DICK VAN DYKE ADDICTION TREATMENT CENTER – KITCHEN & DINING ROOM ADDITION INCLUDING ASBESTOS ABATEMENT PROJECT

ADDENDUM # 003

Date Issued: September 30, 2026

1 STAGING PLAN
SCALE : 1" = 30'-0"

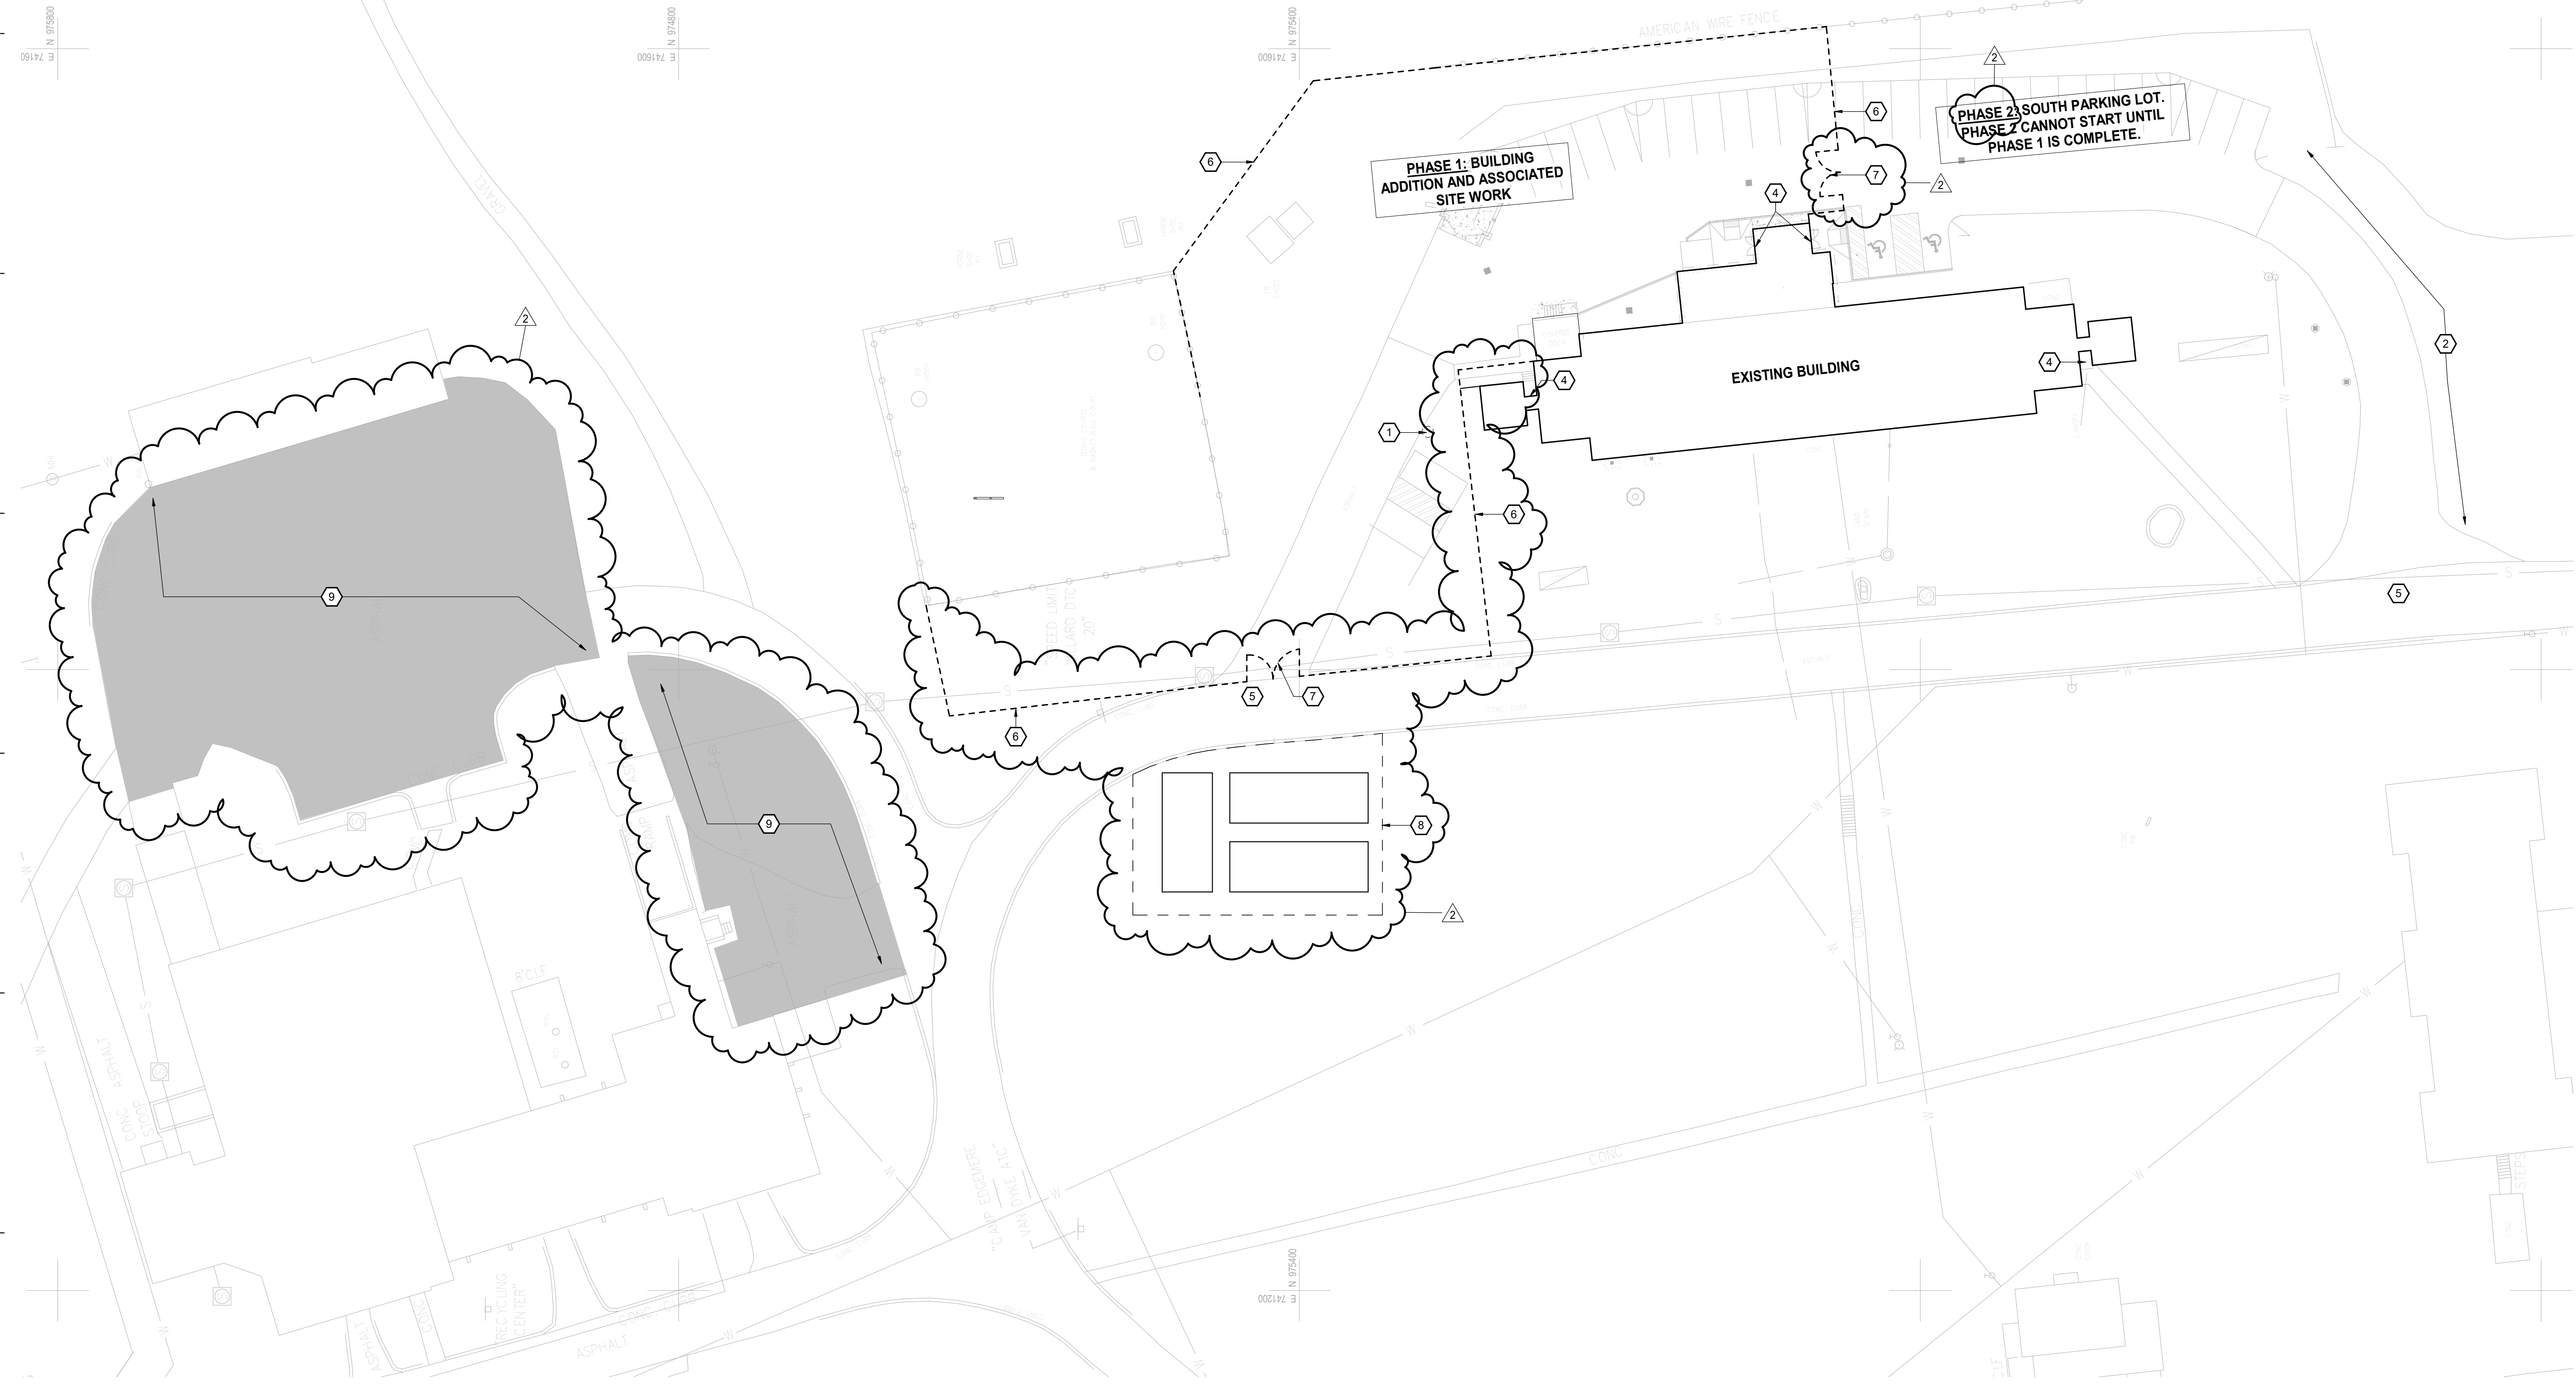
1. Sheet G005 - STAGING PLAN
 - a. **MODIFY:** Extents of fencing.
 - b. **ADD:** Office trailers and storage trailer locations, material stock yard and equipment parking. Keynotes added to sheet to reflect these items.
2. Sheet M701 – MECHANICAL CONTROLS DIAGRAM
 - a. **ADD:** New drawing; added control diagram.
3. Sheet P100 – BASEMENT SANITARY & VENT PIPING PLAN
 - a. **ADD:** Combination waste/vent piping from floor sink on first floor.
4. Sheet P101 – FIRST FLOOR SANITARY & VENT PIPING PLAN
 - a. **ADD:** Combination waste/vent piping and floor sink to serve freezer and cooler, plus keynote 11.
5. Sheet E300 – BASEMENT SPECIAL SYSTEMS PLAN
 - a. **MODIFY:** Keynote 2 to include VALCOM as basis of design.
6. Sheet E301 – FIRST FLOOR SPECIAL SYSTEMS PLAN
 - a. **MODIFY:** Keynote 4 and 8 to include VALCOM and JCI as basis of design.

M701

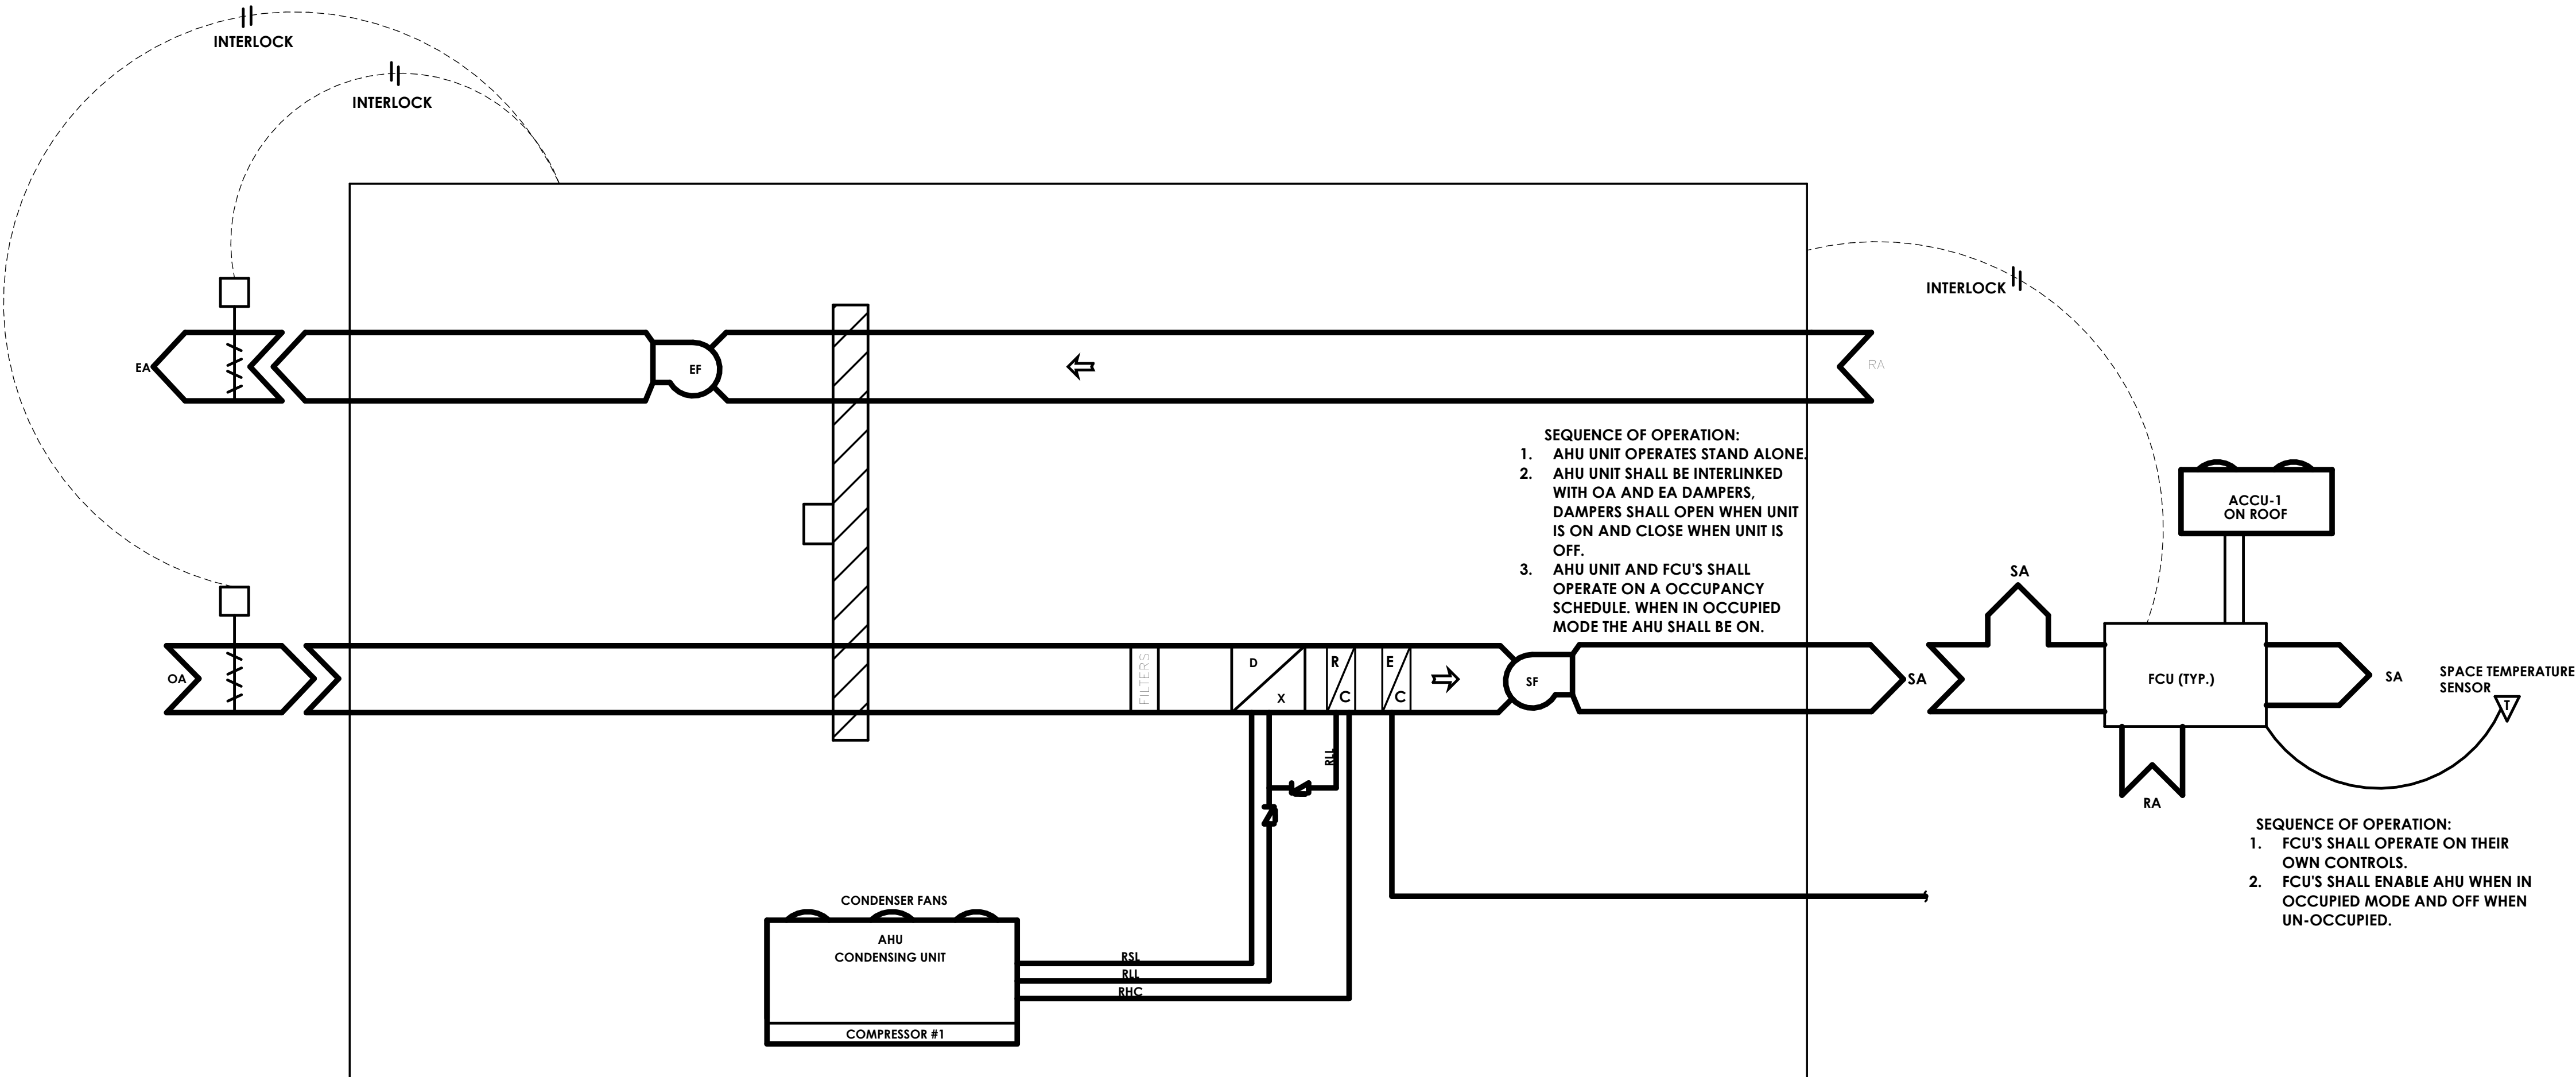
3. Can you verify who owns the controls in the building. No spec section is provided in the documents.
 - **RESPONSE:** See drawing M701 issued as part of Bid Addendum #003 for control diagram.

1 BASEMENT SANITARY & VENT PIPING PLAN
SCALE : 3/16" = 1'-0"

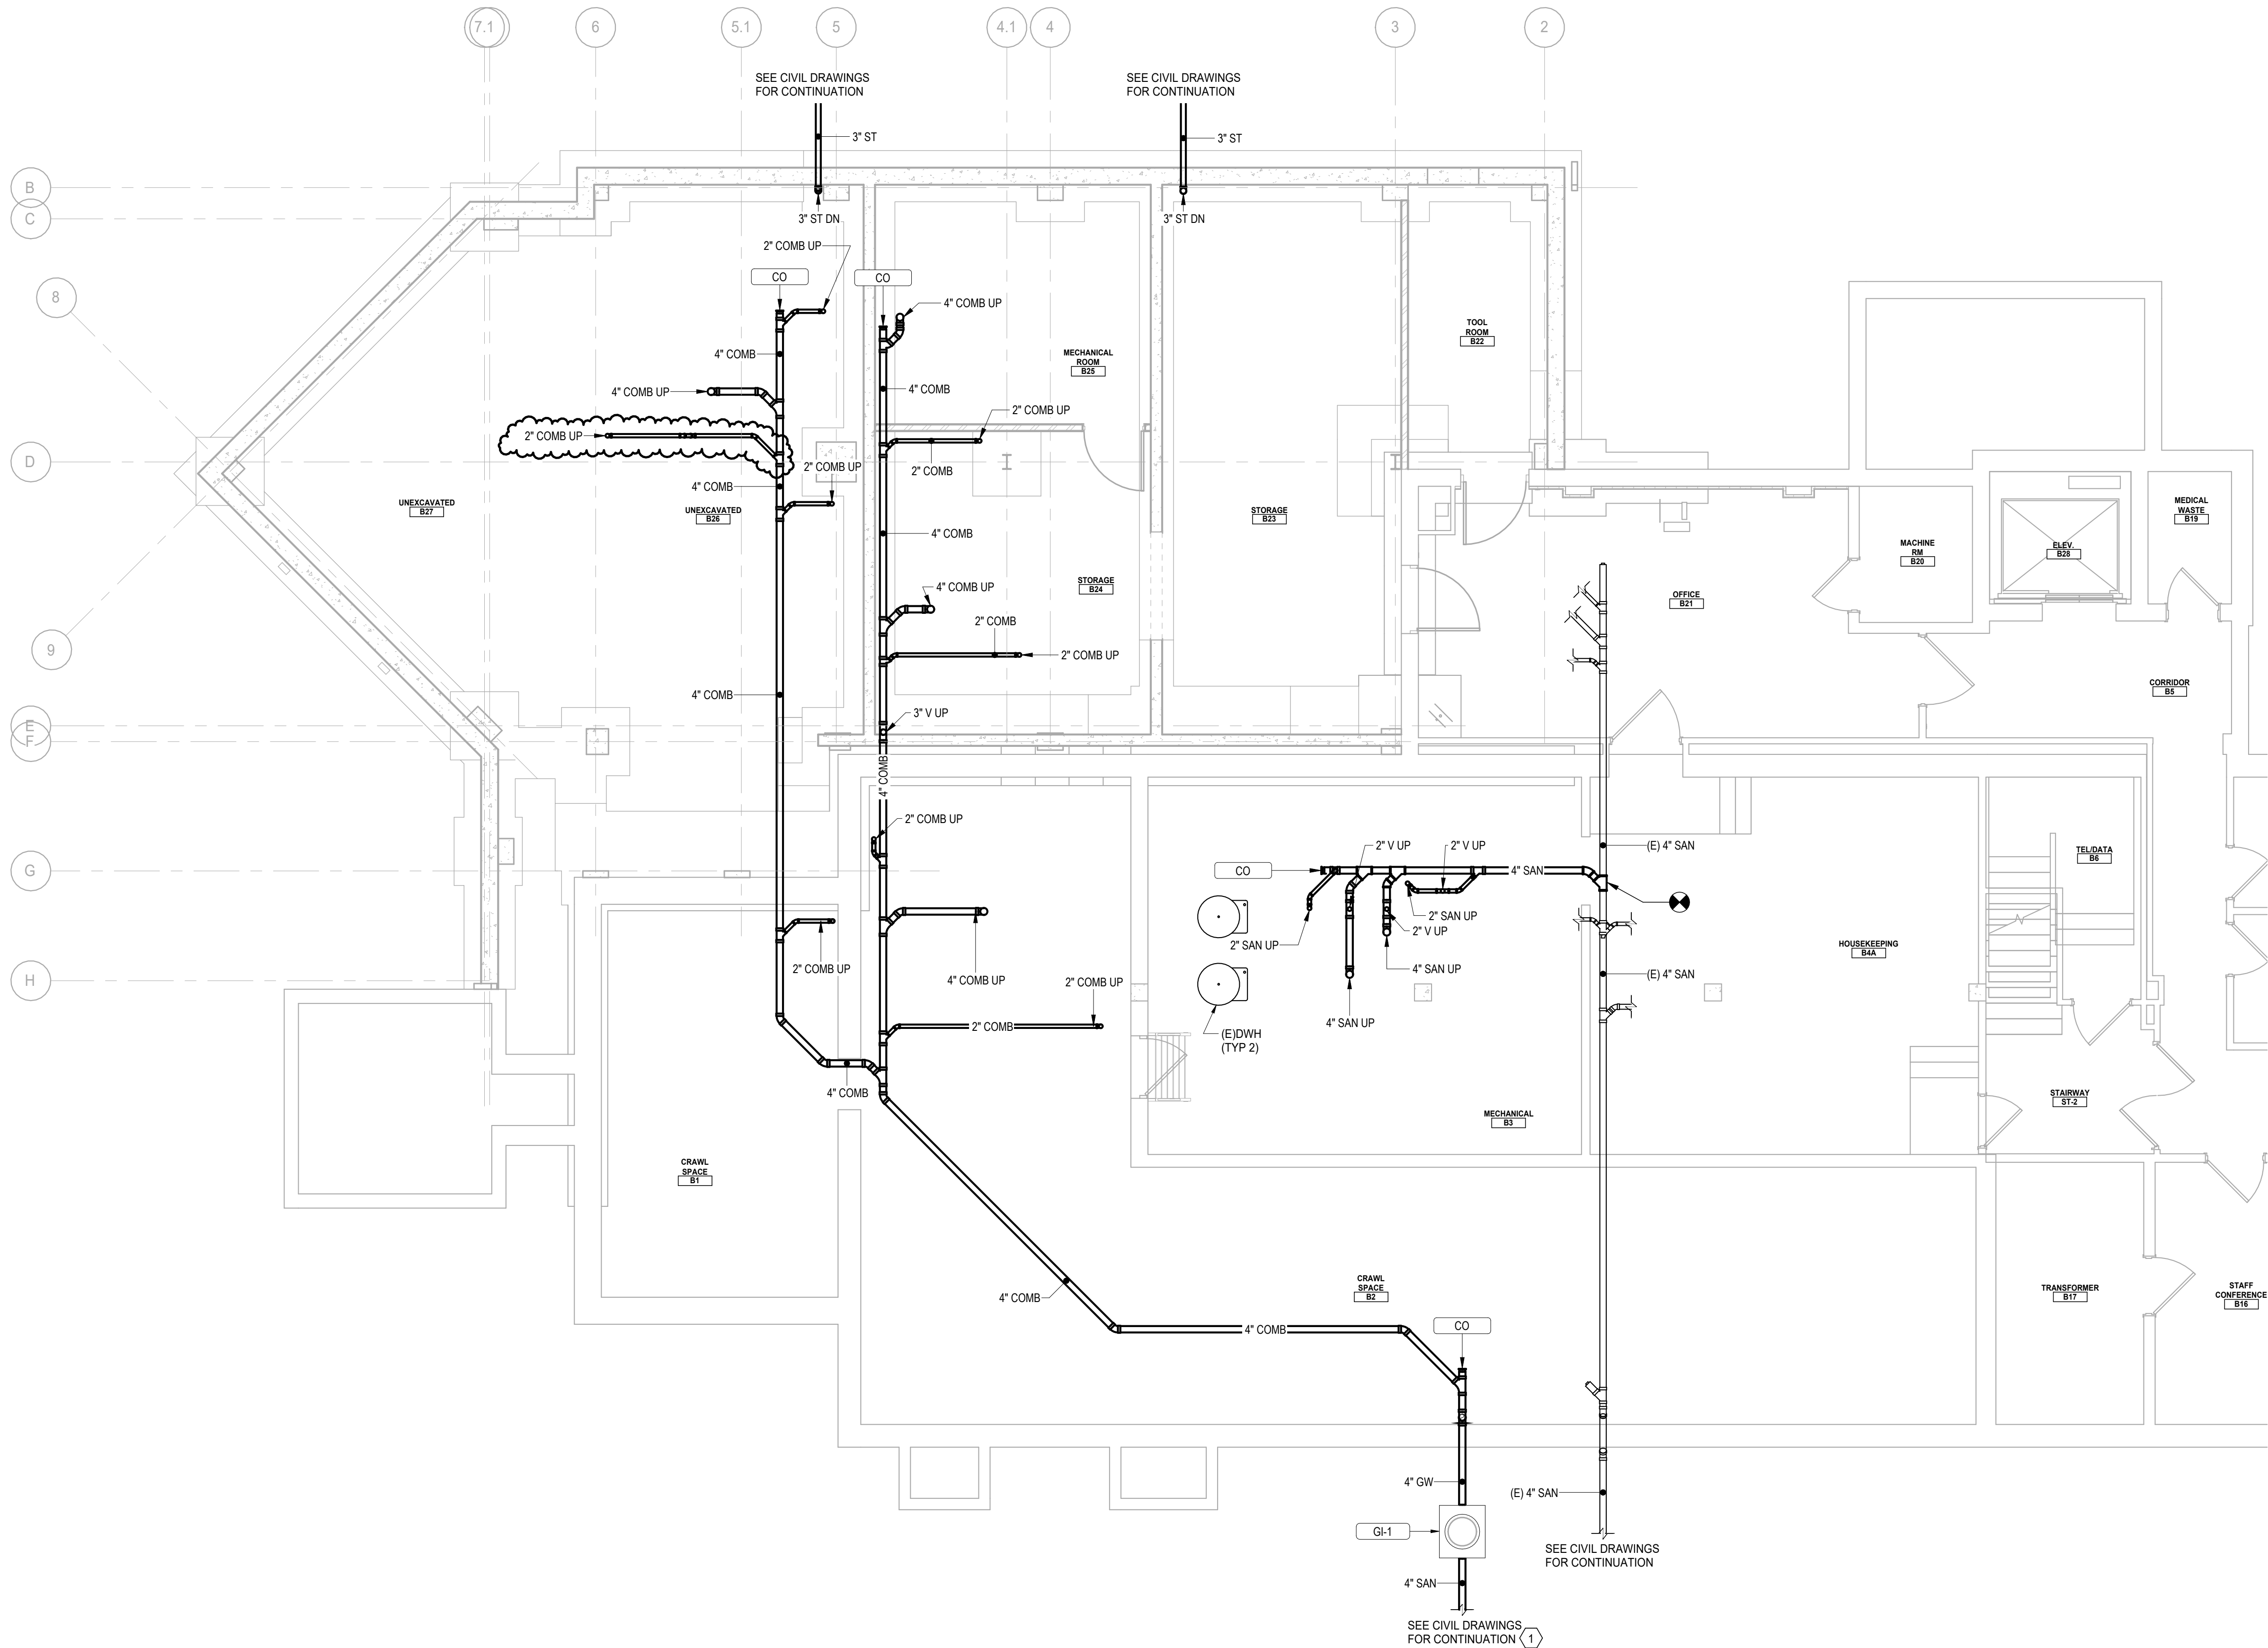
1. Please provide a spec section for louver L-1 and L-2 that can be found on M101 and in the schedule on M600.
 - **RESPONSE:** Contractor to buy the model and submit comparable products as shown on M101 and M600 drawings.
2. FSE-2 Kitchen plumbing plan, items no. 9.1 and 9.3 evaporator drains. Where are these to drain?
 - **RESPONSE:** See drawings P100 and P101 issued as part of Bid Addendum #003.
